## Addendum No. 6

Austin Masjid  
800 N Heatherwilde Blvd., Pflugerville, TX 78660  
June 19, 2026

Project Number: 2305

**P2.00**

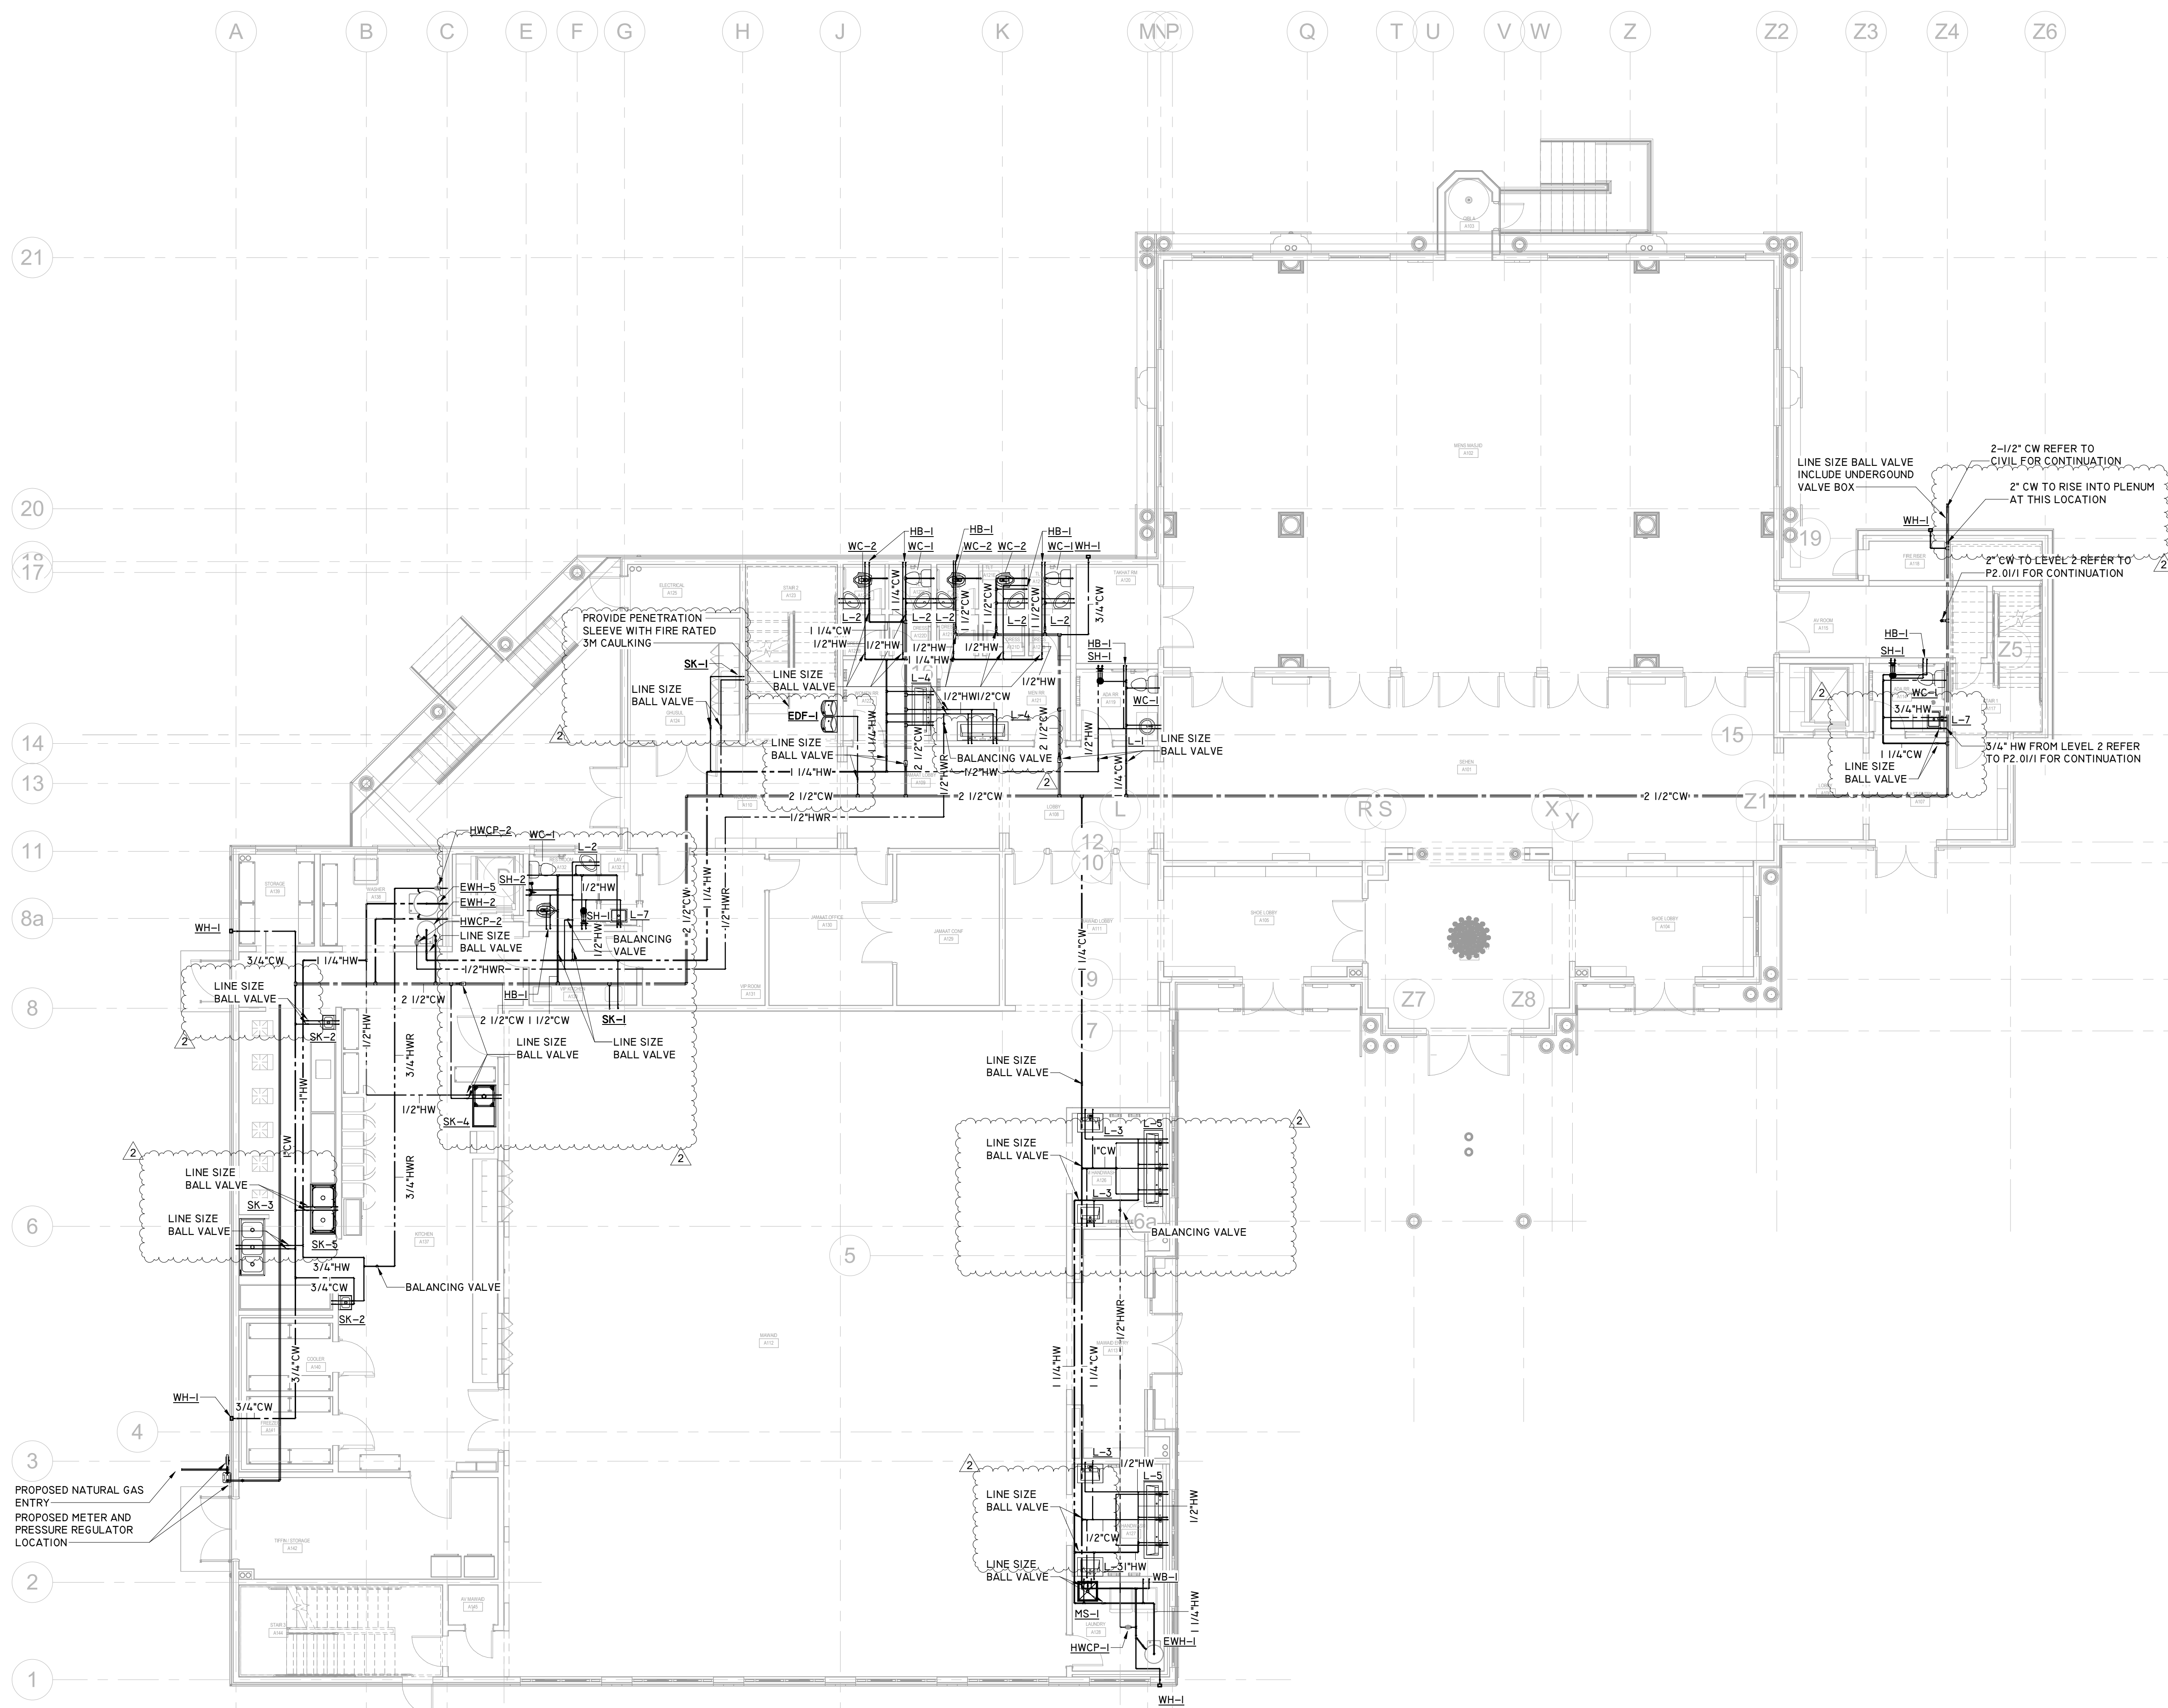
P2.00 ADJUSTED PIPING, ADDED AND TAGGED SHUT OFF VALVES. ADDED NOTES.

**P3.00**

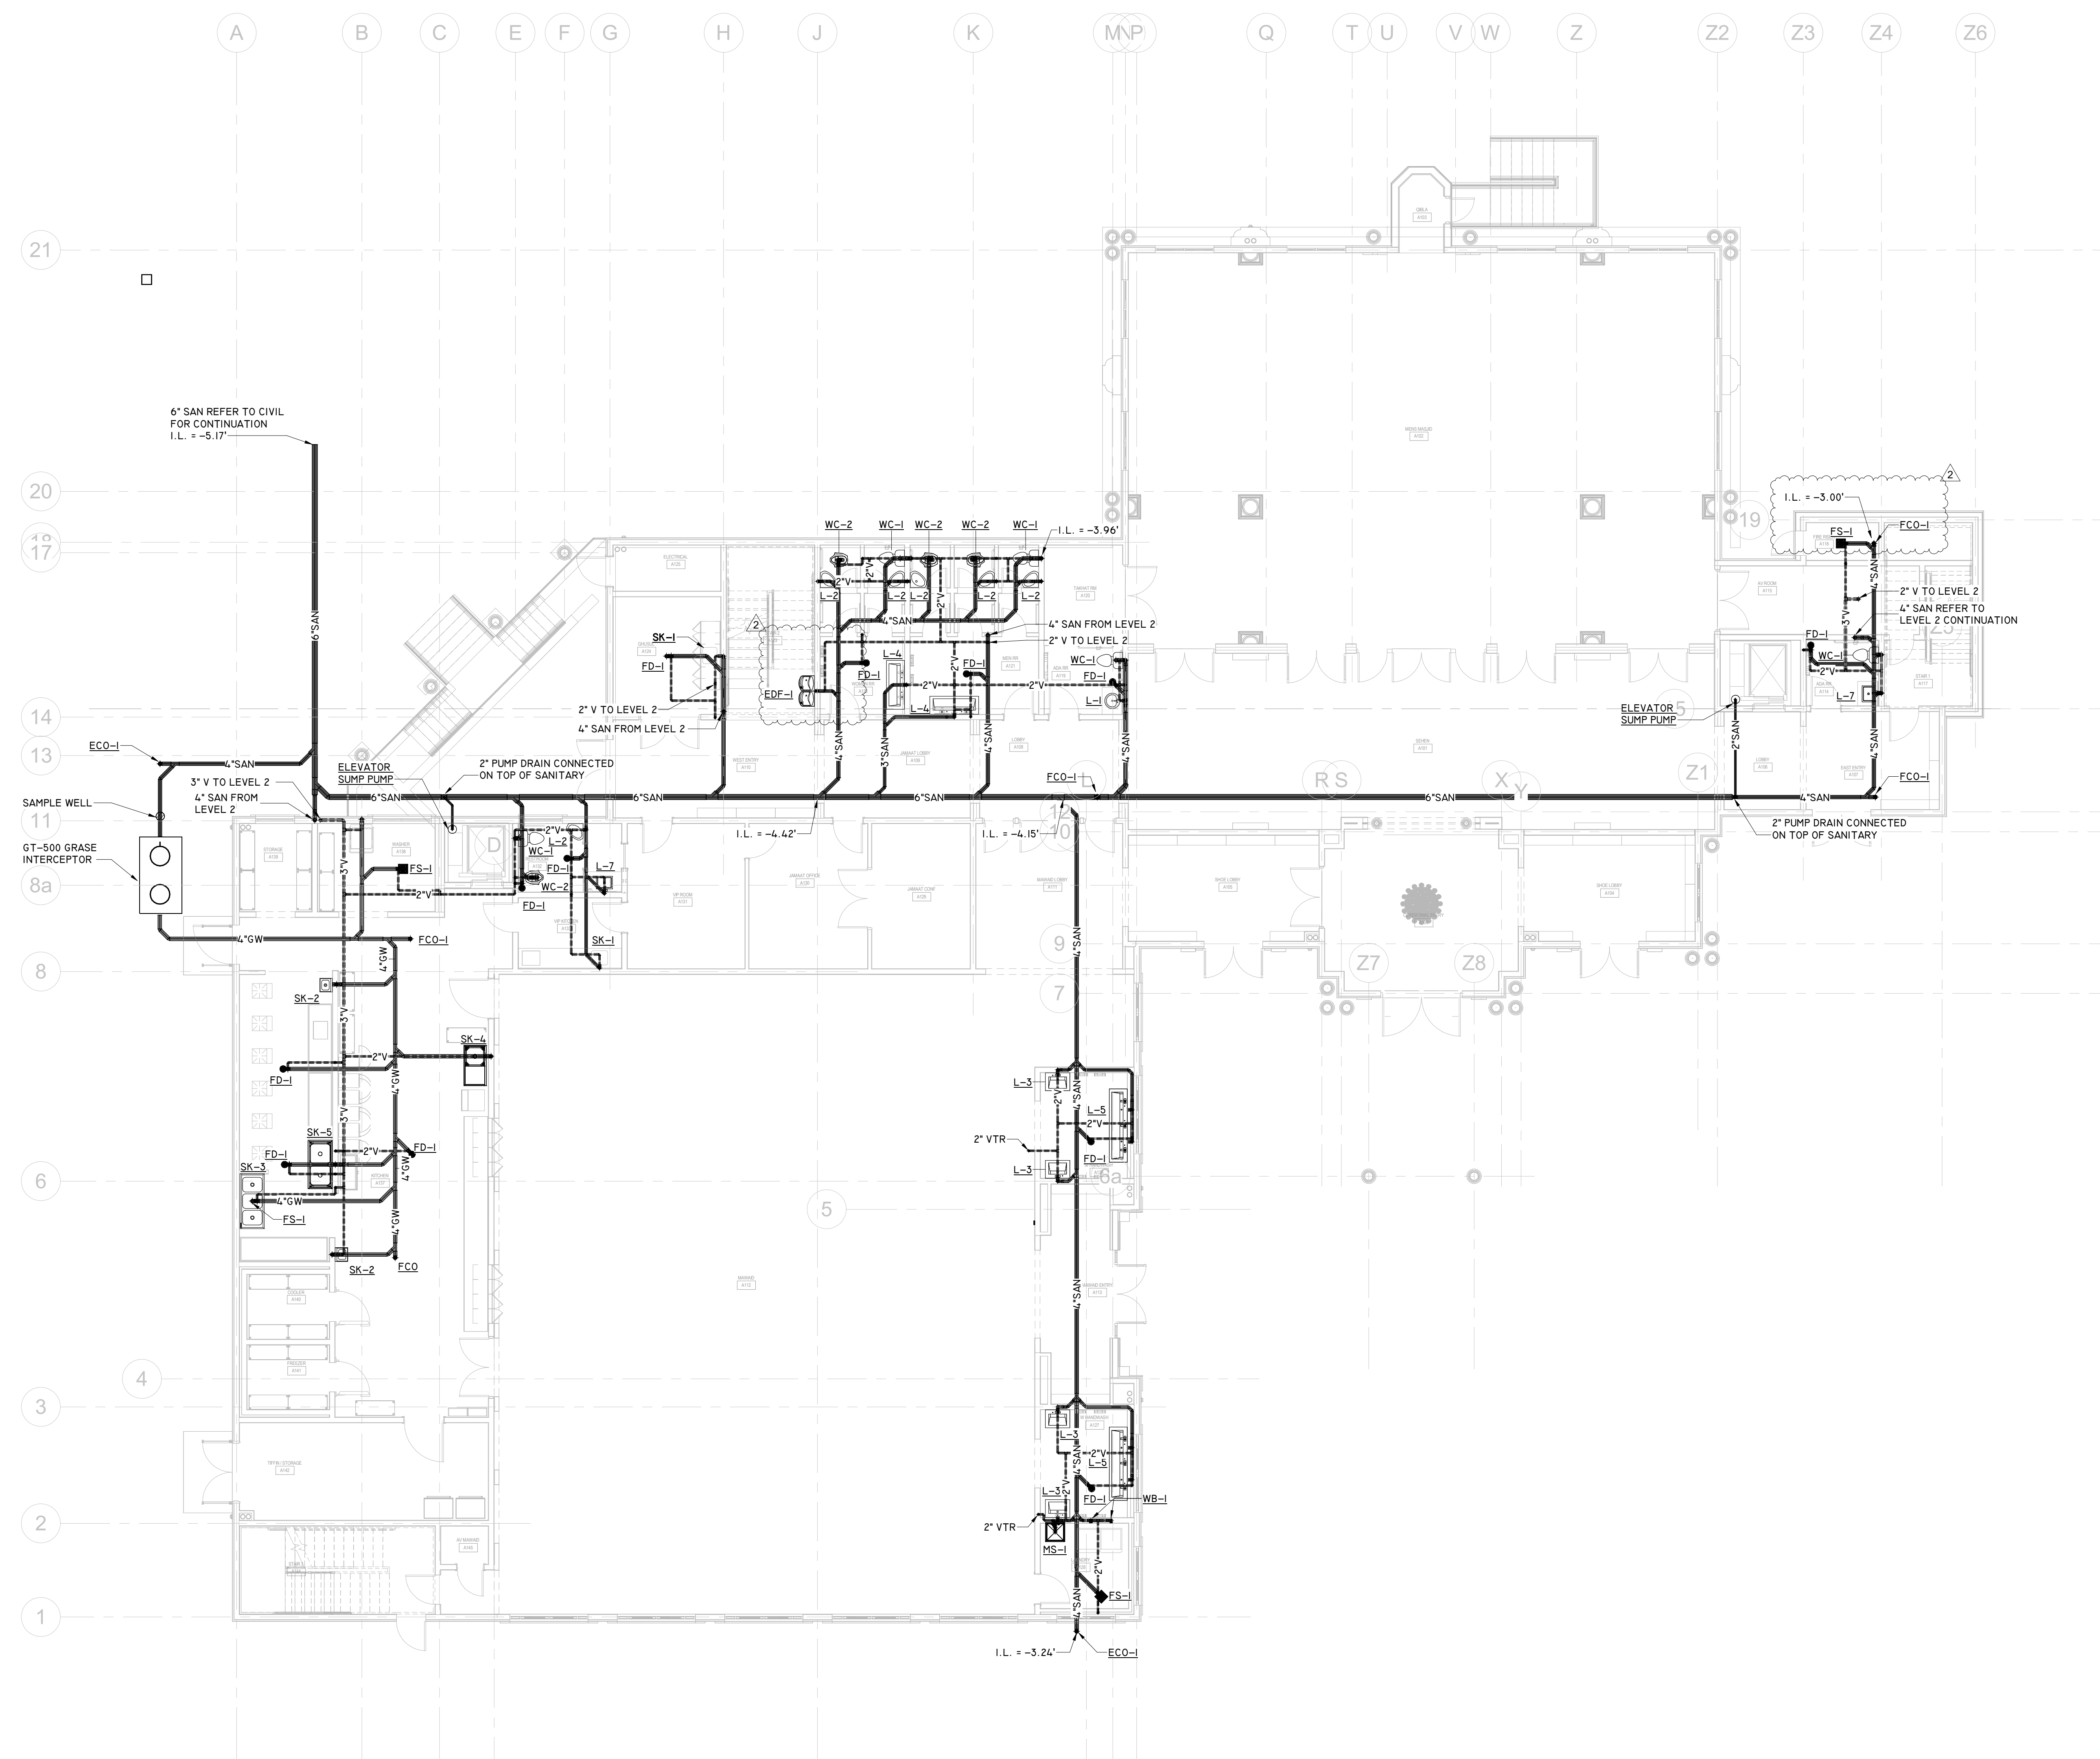
P3.00 ADJUSTED PIPING, ADJUSTED TAGS. ADDED NOTES.

SHEET NUMBER  
**P4.01**

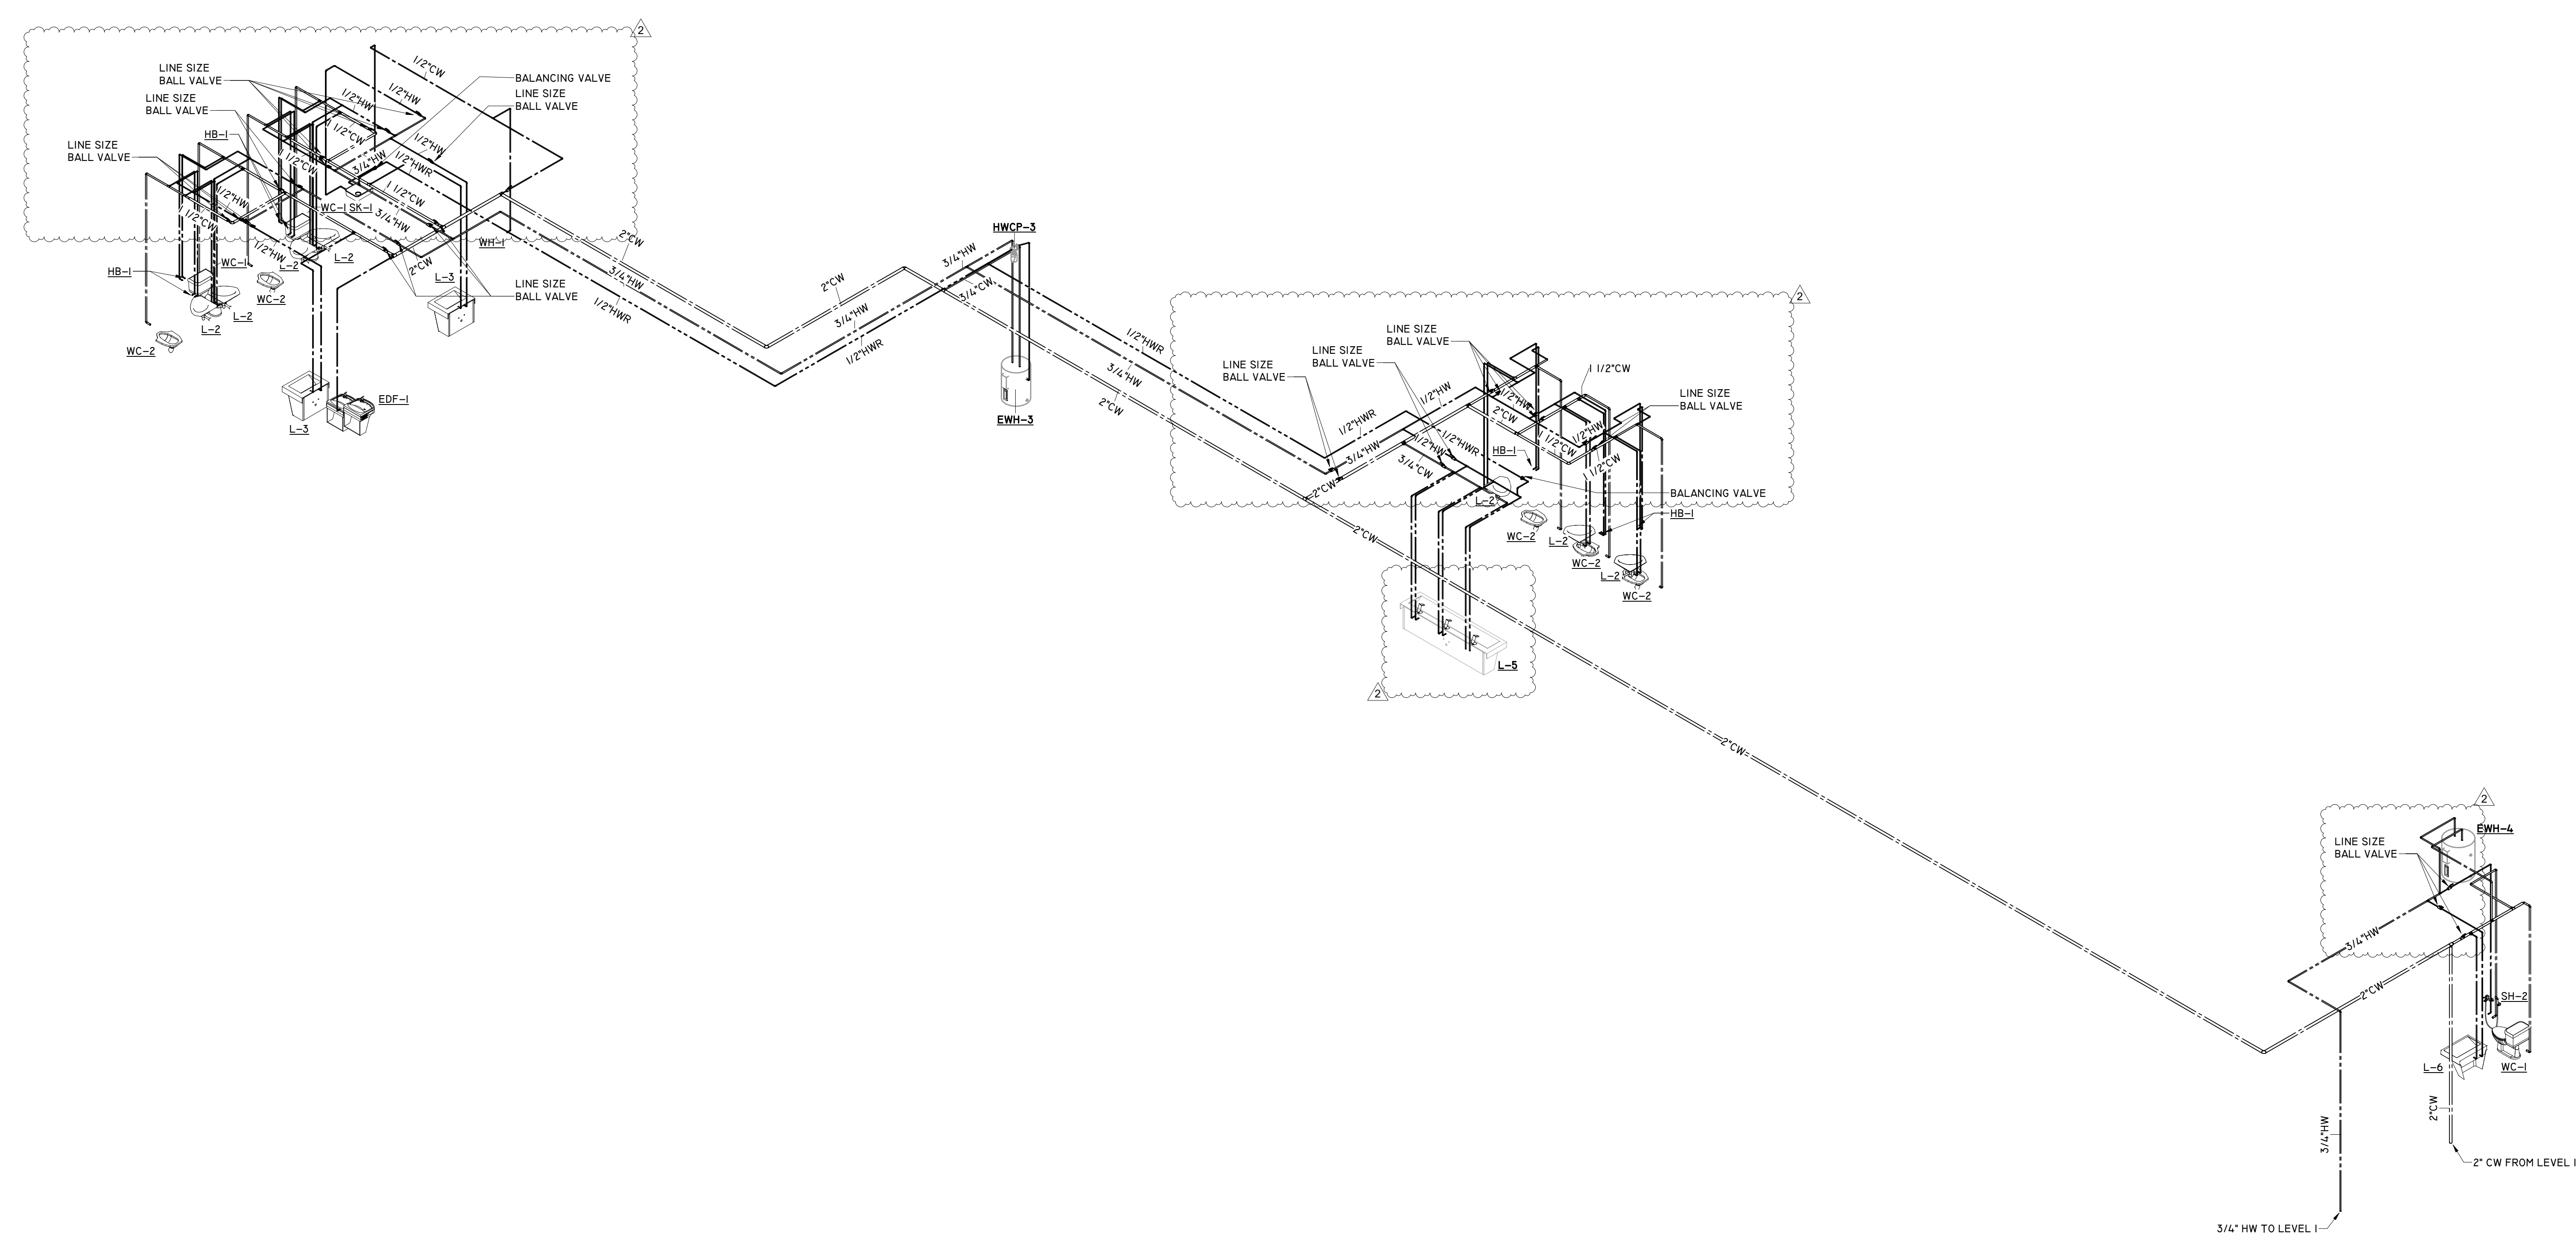
P4.01 ADJUSTED TO MATCH FLOOR PLAN. ADJUSTED TAGS
